ENGINEERING CHANGE NOTICE

1. ECN 666067

6. Project Title/No./Work Order No.	7. Bldg./Sys./Fac. No.	8. Approval Designator	
		Interim Stabilization, Essential Drawings, 113340	241-G/200-GEN	N/A

RPP-7567, REPORT ON NEW PUMPING SYSTEM SOFTWARE ON PUMPING
INSTRUMENTATION AND CONTROL SKIDS

LAD 21 - - INJECTION FLOW TOTALIZER --- Total Rungs in File = 9

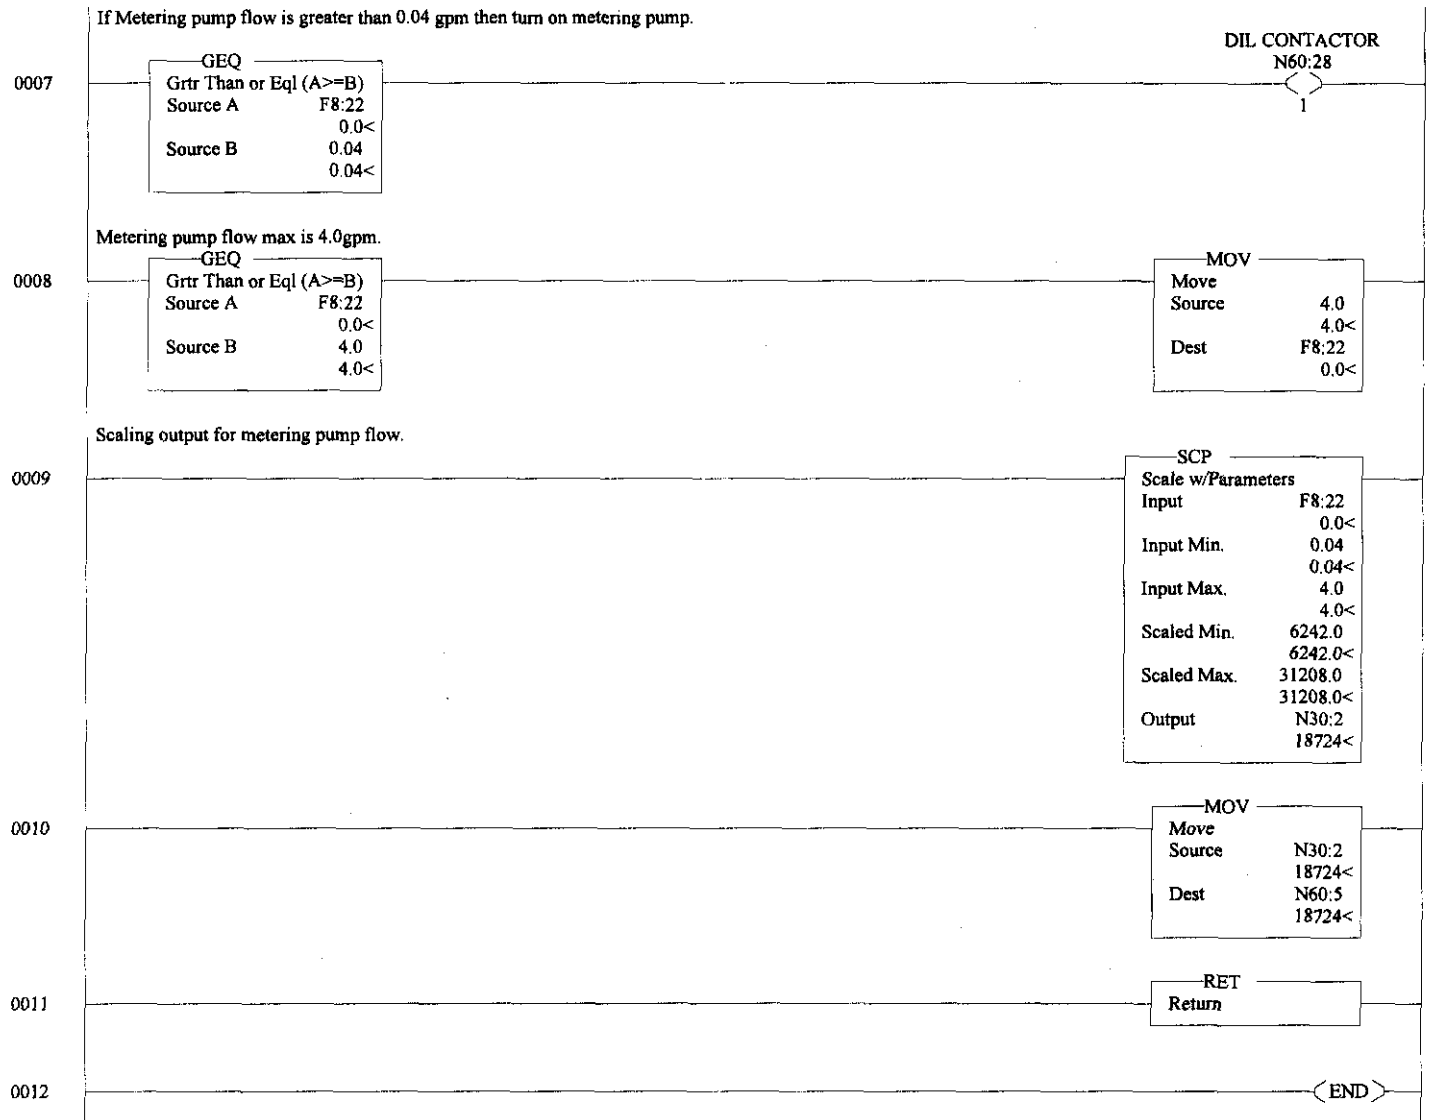
6.11 Ladder 21 is a new subroutine for calculating the volume of injection water to the new saltwell pump. Two assumptions used in this routine are that the water flow remains constant and that the nearest whole gallon readout is sufficient. The volume readout is provided on a DTAM screen in gallons. The routine used is similar to the total value calculated for the waste volume from gathering the flow rate from the flow meter. This method is used because it is assumed that more than 32,767 gallons will be used which is the maximum number that can be stored in any file in the PLC. A larger value will cause an error in the PLC program. The main difference is the flow meter is sending out a 4 to 20mA signal. Here a discrete signal is used to start the process. The calculation functions as follows.

6.11.1 Rung 0 starts the subroutine when the injection water flow switch closes making contact N60:30/10 **TRUE**. The 60-second retentive timer starts. A retentive timer is used because if the flow switch opens during the timer-timing phase the time is kept. This prevents any flow data from being lost due to the timer being reset during the timing phase. Since the flow rate used in the calculation is a value entered in at the DTAM in gallons per minute, the 60 seconds makes the calculation easy by simply adding the flow rate every minute.

6.11.2 Rung 1 becomes **TRUE** when the 60-second timer times out. The flow rate that is stored in file F90:3 (the value entered from the DTAM screen) is added to the accumulative value file F90:1 and then stored back into the same file F90:1.

6.11.4 Rung 3 becomes **TRUE** when the accumulative value in file F90:1 is equal to or greater than one. When this occurs, one is subtracted from the accumulative value and the result stored back into the accumulative file. At the same time the C5:4 counter is increased by one. When counter C5:4 becomes 10,000, then the C5:4-done contact become **TRUE** causing counter C5:5 to increase by one and resetting the C5:4 counter back to zero.
